TRANSMITTAL COVER SHEET

DATE: 21 June, 2024
TO: ALL PLAN HOLDERS OF RECORD
FROM: HUNTER SWATEK, AIA, PROJECT MANAGER
PROJECT: RAINBOW CITY RECREATION CENTER
GMC PROJECT NO. ABHM230021
RE: ADDENDUM NO. 3 AND
ACKNOWLEDGEMENT OF RECEIPT OF ADDENDUM NO. 3

ADDENDUM NUMBER 03

**PROJECT: RAINBOW CITY RECREATION CENTER
GM&C PROJECT NO. ABHM230021**

SECTIONS
S3.04

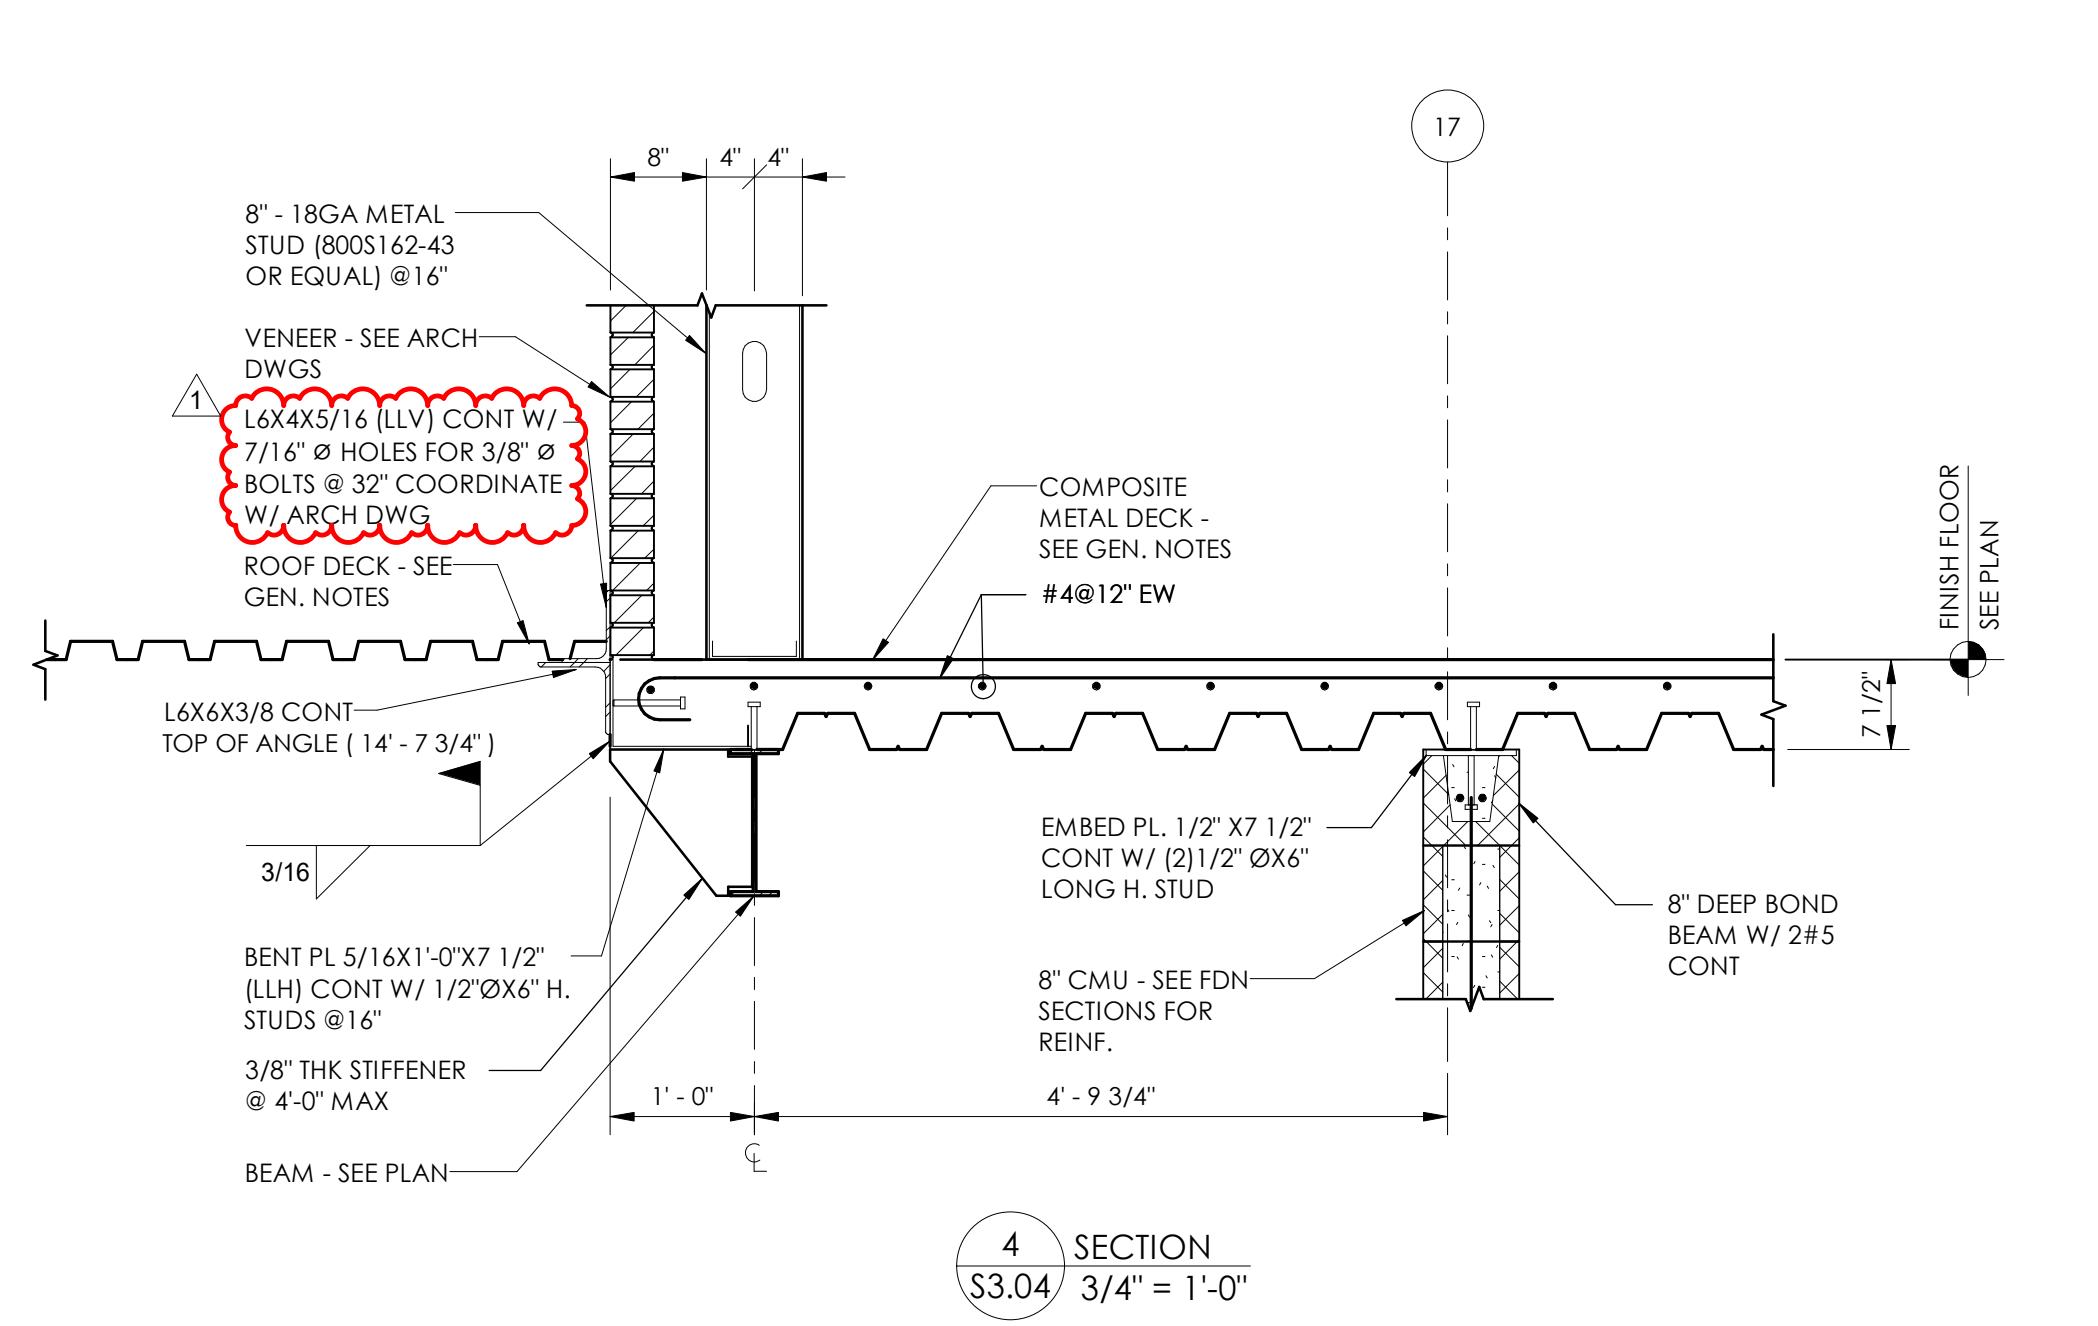
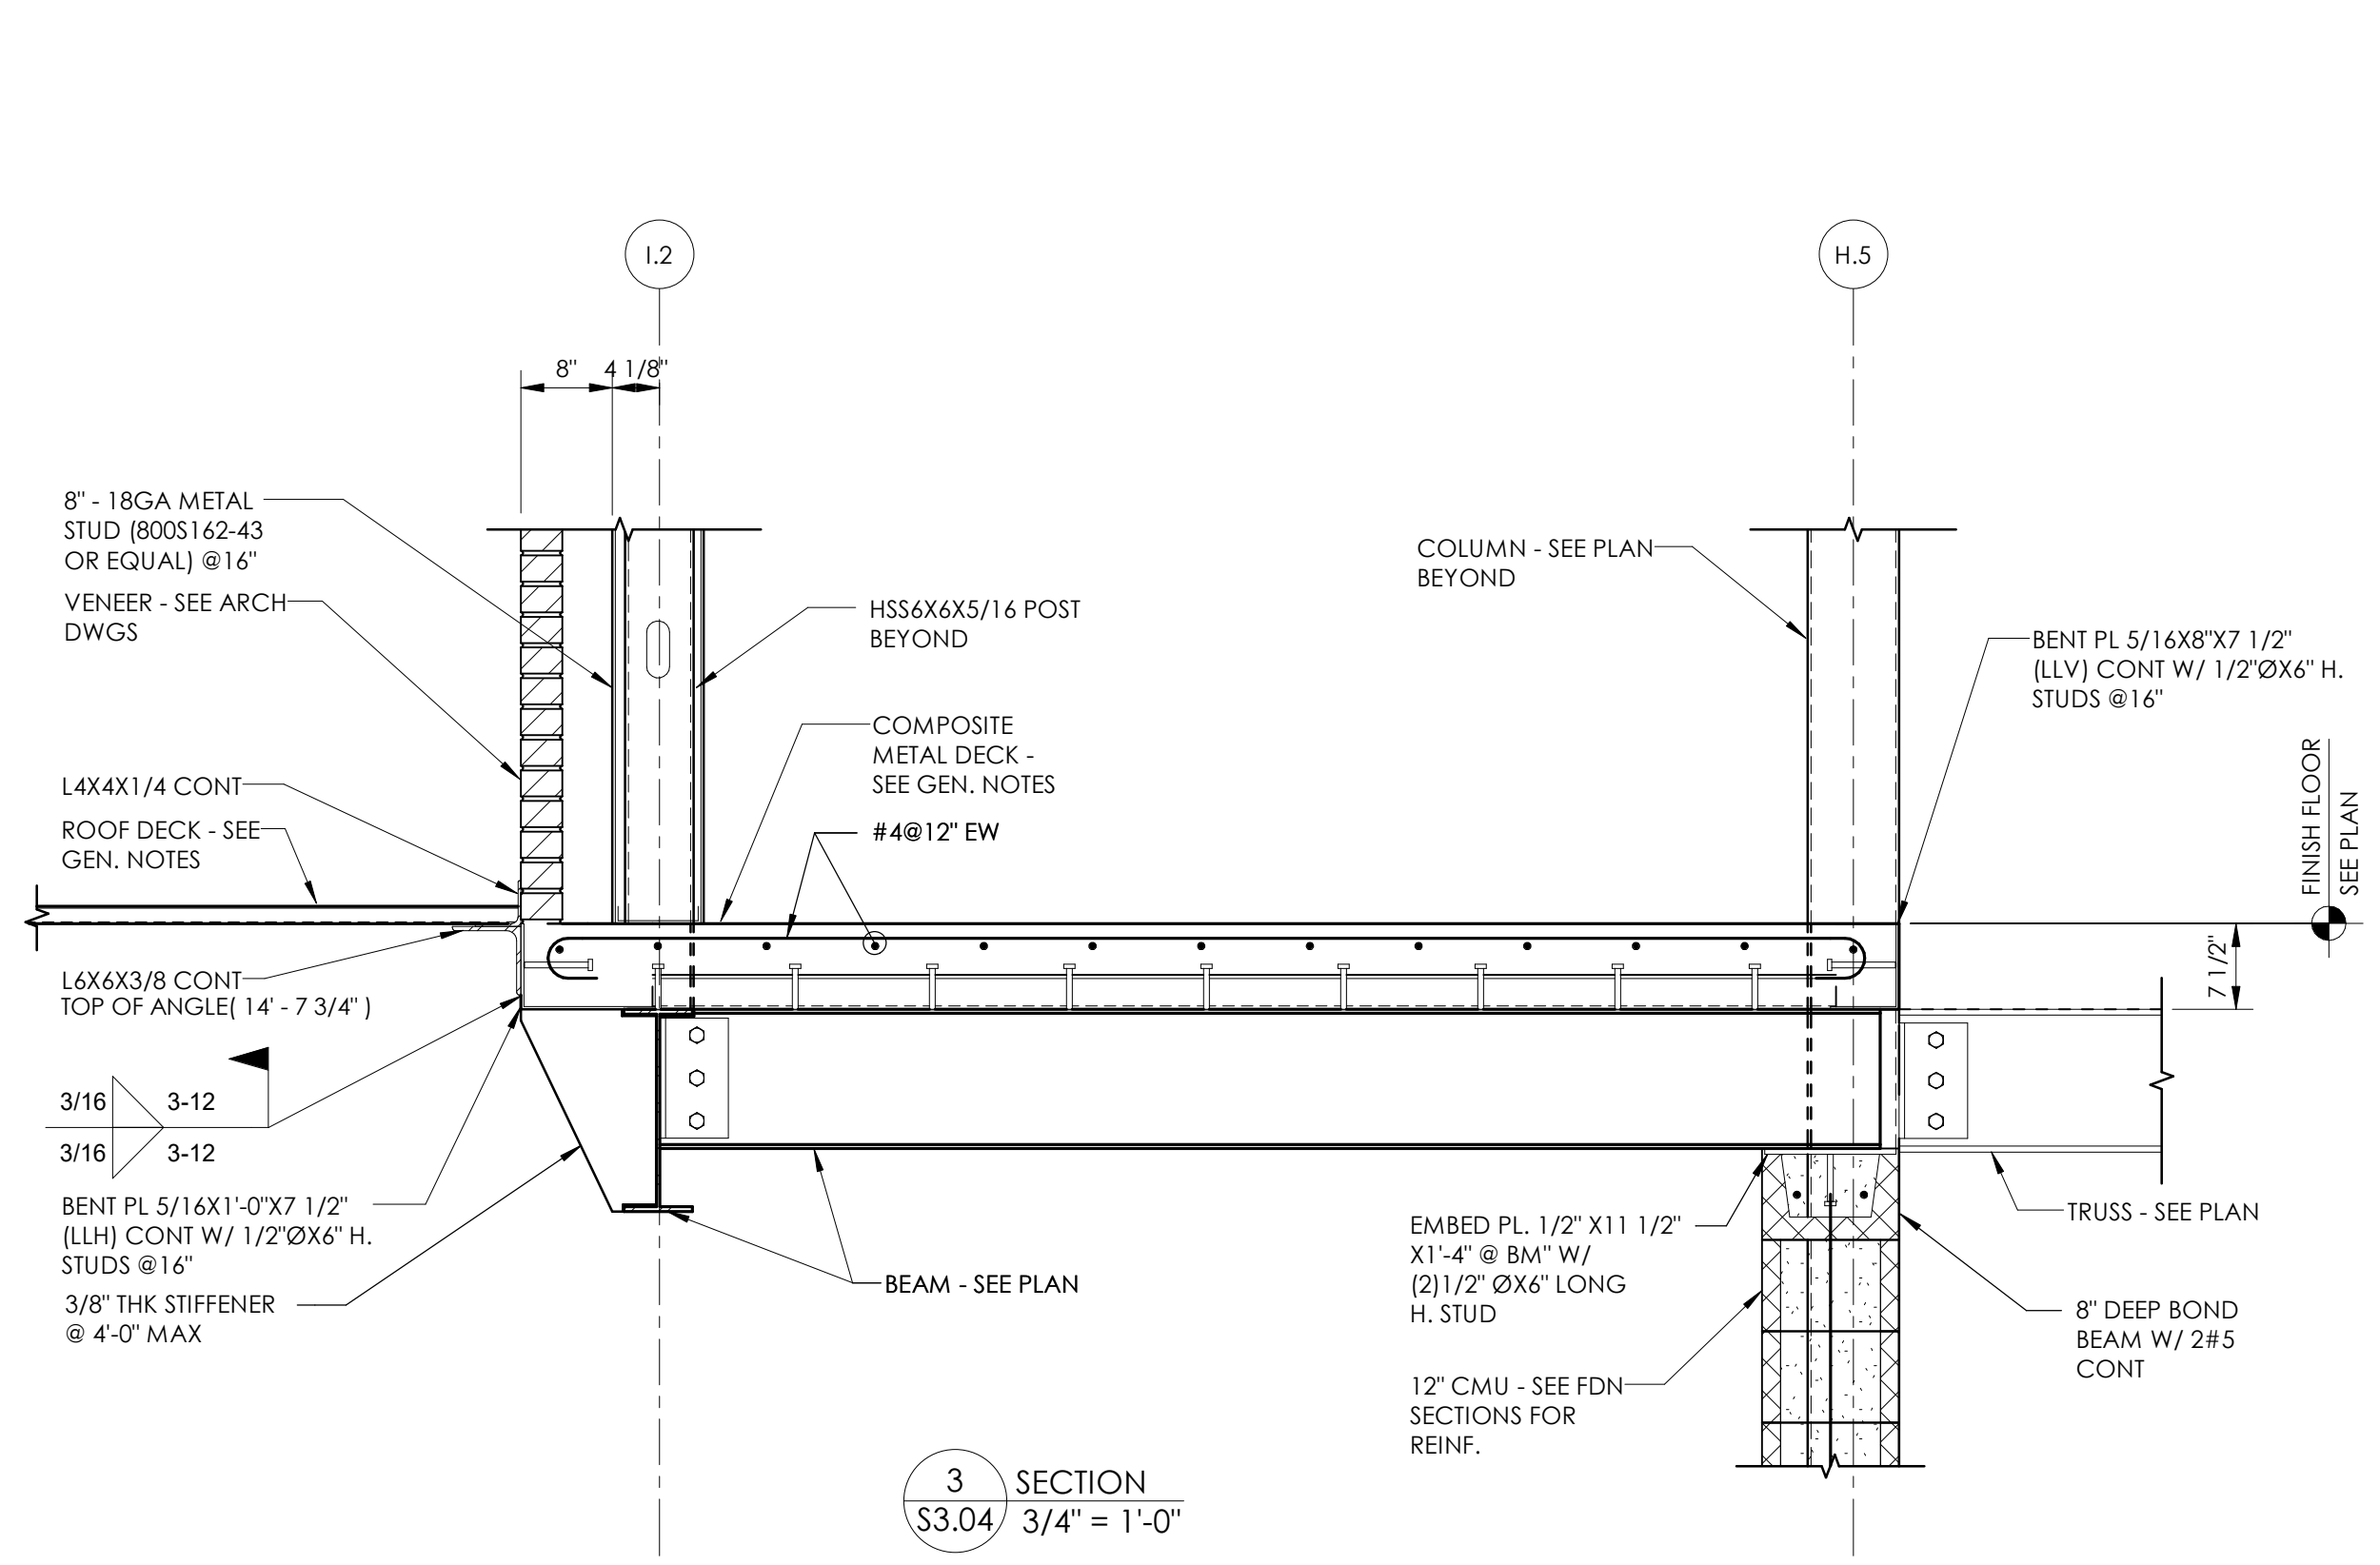
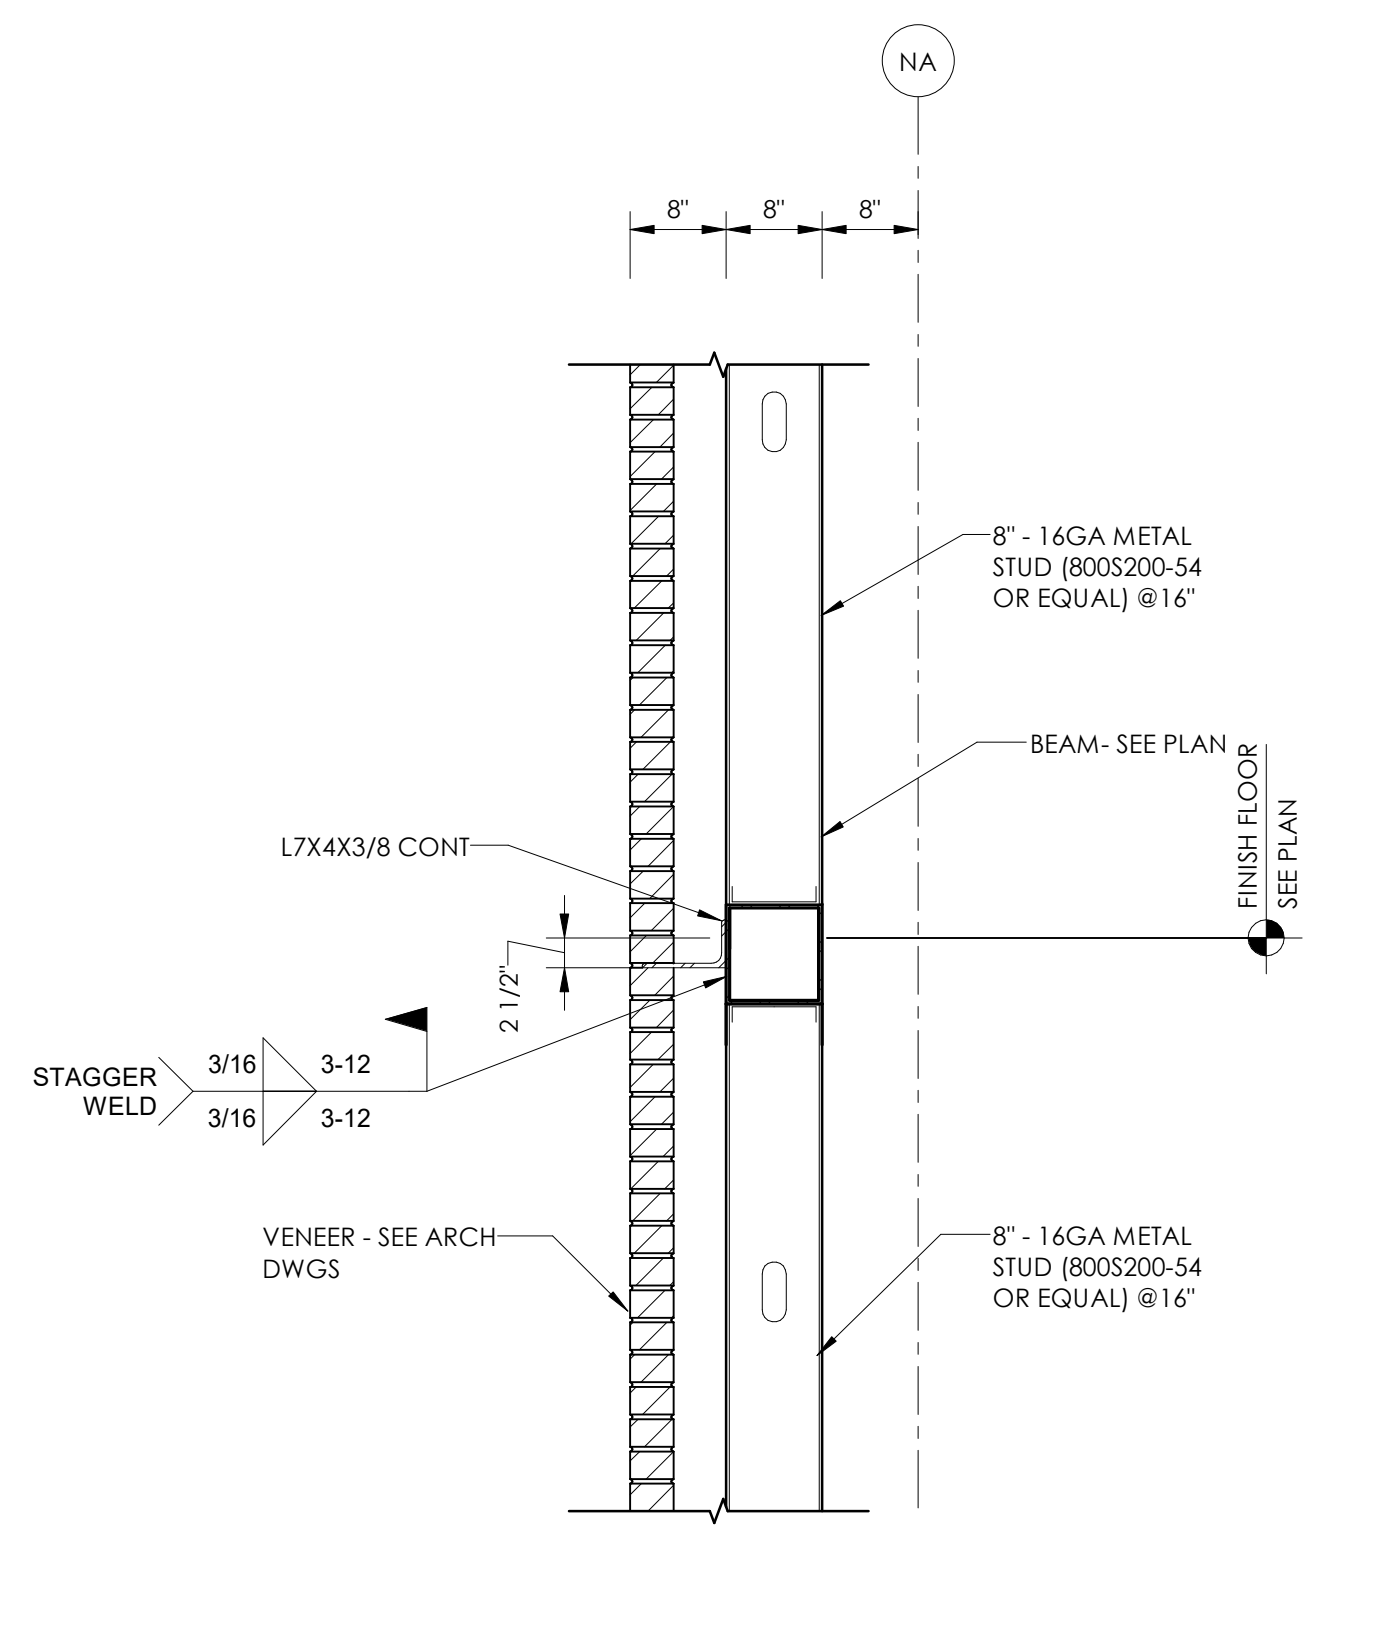
- a. ADDED Sections
- Y. **S3.02** – Sections
 - a. REVISED Angle size
- Z. **S3.03** – Sections
 - a. REVISED Angle size
- AA. **S3.04** – Sections
 - a. REVISED Sizes
